## K2 SSB Modifikation

A compilation of the mods suggested by John, KI6WX, Karl-Heinz, DF7KHK and Frank, DJ3FR by DL2FI

### Improving the Quality of the modulation, Solving the problem of less driver power on the upper bands

#### MOD 1: KSB2, More Gain for SSB

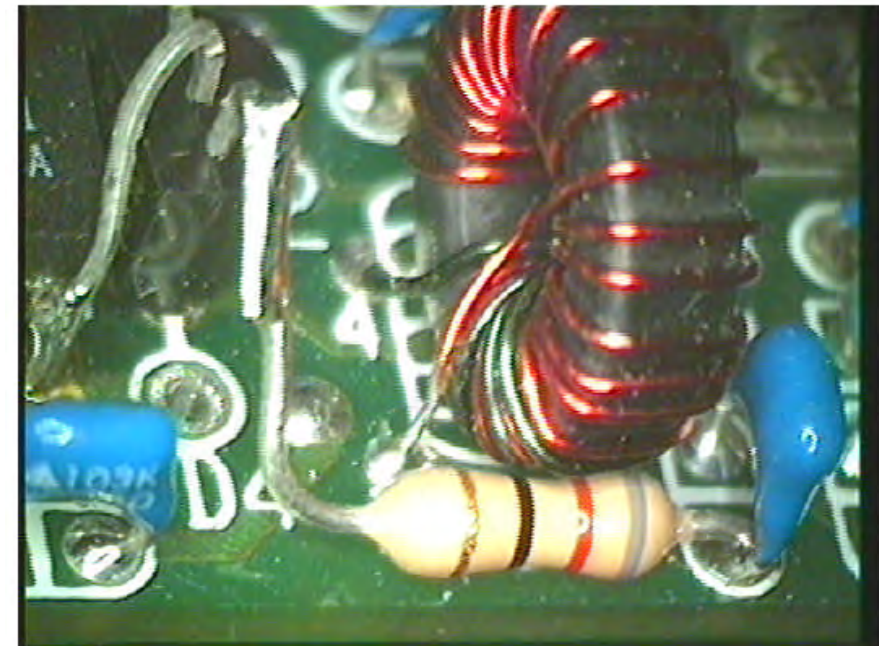
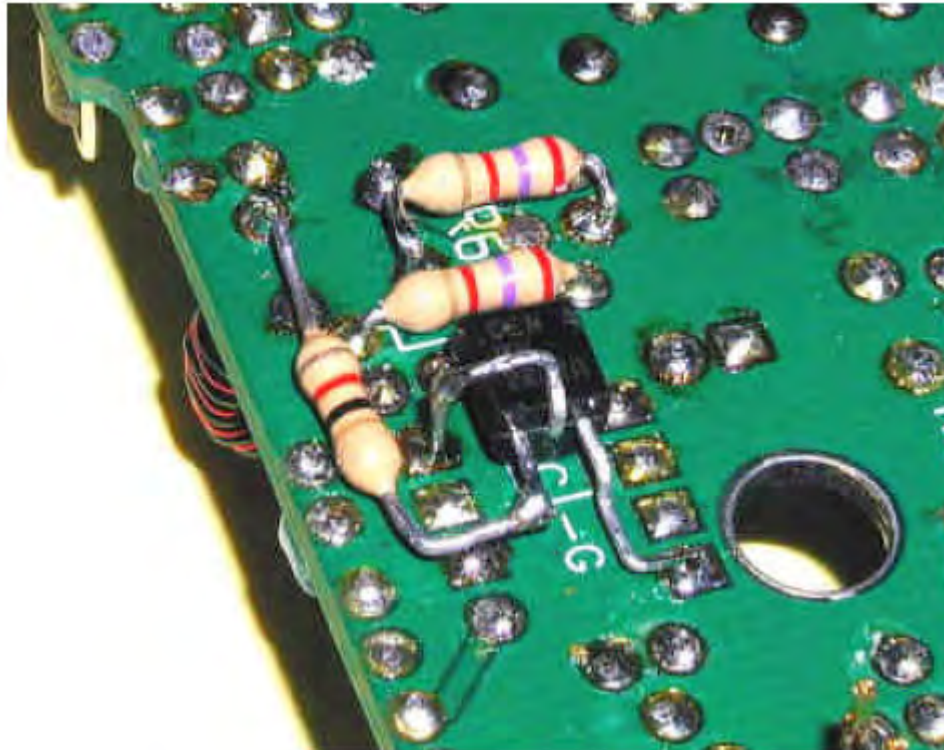
The original SSB board has a little bit low gain. If a mirophone with low output is used, it cannot drive the K2 to full power at the high frequency bands. Using microphones with higher levels it can happen, that the NE602 is over driven with causes AF clipping. This mod is a clean solution for both problems.

John is using a PN2222 Emitter follower to cople the NE602 to the low impedance side of transformer T2. This way he uses the Voltage transformation of T2 and gives a much lower load to the NE602 output stage. The 82 Ohm resistor together with the impedance of the Emitter follower gives a good Imedance matching for the Xtal Filter. The resulting gain of this mod in total gives a plus of about 10 dB..

- [ ] **Remove D4**
- [ ] Desolder wire number 2 and wire number 4 of T2 ( you find them next to the NE602).
- [ ] Now solder former number 4 wire to solderlug number 2 and former

number 2 wire to solderlug number 4. This will reverse T2 by 180 degrees.

[ ] Install a **PN2222** (attention, 2N2222 has another pinning). Place it at the right side of NE602 the flat side orientated towards NE602. The 3 Pins look upwars.

[ ] Solder colector to PIN 8 of NE602

[ ] Solder Base to PIN 4 of NE602

[ ] Solder a 82 Ohm Resistor between Emitter and PIN 1 of T2. Use the solderlug of C11.

[ ] Solder a 2,7kOhm Resistor between wire 4 of T2 and ground at the solder side of the PCB. ( Use the junction between R6 and T2/4. This resistor will hold the Base/Emiter junction of PN2222 at 3V to avoid Base/Emitter breakthrough.

## MOD 2: Decreasing distortions

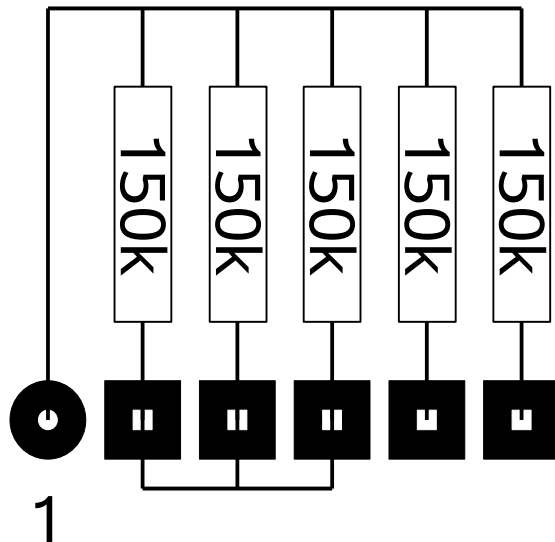
If the Level for the NE602 Input gets to high, this will cause AF clipping what means Intermodulations and Distortions of the AF signal.

To avoid this, we add a Resistor.

[ ] Check R2. If it is not 5k6 replace it with 5k6.

[ ] Solder 2k2 resistor between PIN 1 and PIN 2 of U5. This can easy be done if you use the input / output pins of Trimpot R1 (do not use the slider PIN)

Upper drwaing: Original KSB2  
Lower Drawing: Modified KSB2

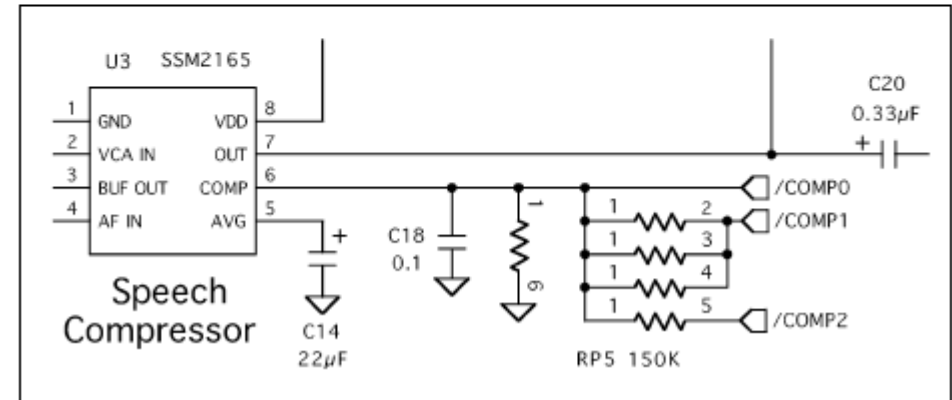
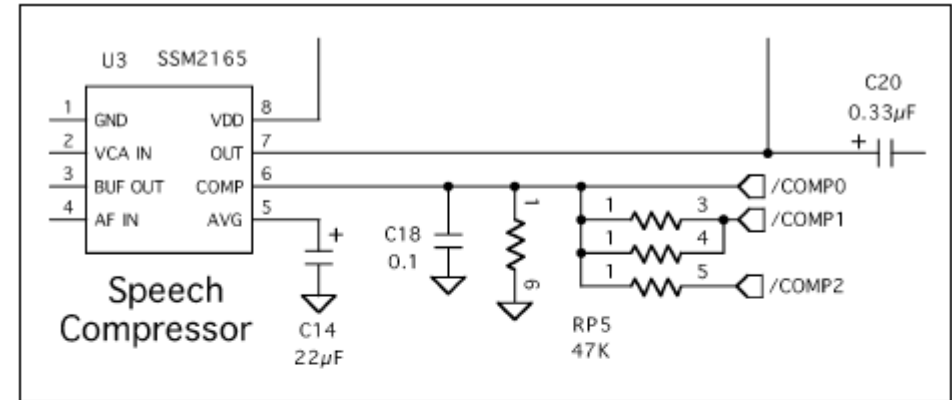
The SSM2165 can be used up to a compression of 15:1. Expierence with the German „Speaky“ transceiver say, that it makes sense to use compression up to 1:10 for QRP-SSB Transceivers.

The following mod is simple and allows to stay with the standard menu steps of K2 giving higher compression.

[ ] Remove RP5 on the SSB board.

[ ] Install 5 150 k Resistors instead of the Resistor array, as shown in th edrawing. Connect PIN 2,3 and 4 on the solder side of the PCB.

## Modifikation: Microphone Sensitivity (DF7KHK)

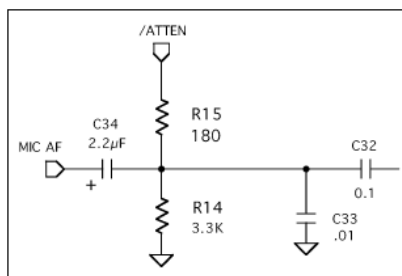
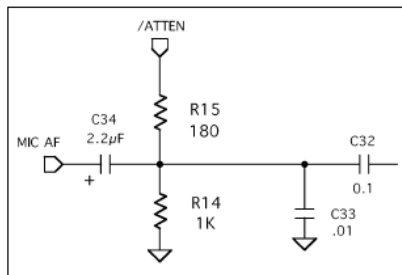
The K2 feeds the the compressor chip directly, not using any preamplifier. Regarding the KSB2 Manual the microphone should give 100mVpp (peak to peak) The Microphone signal is attenuated by R14/R15 using R15 in Menue settig SSBA=1 parallel to R14. If you increase the value of R14, you can use the microphon sensitivity. Using an MH2 Mike, we found 3,3 kOhm instead of the original 1k was the best value.

If you use other Microphones, you may play around with the values of R14/R15
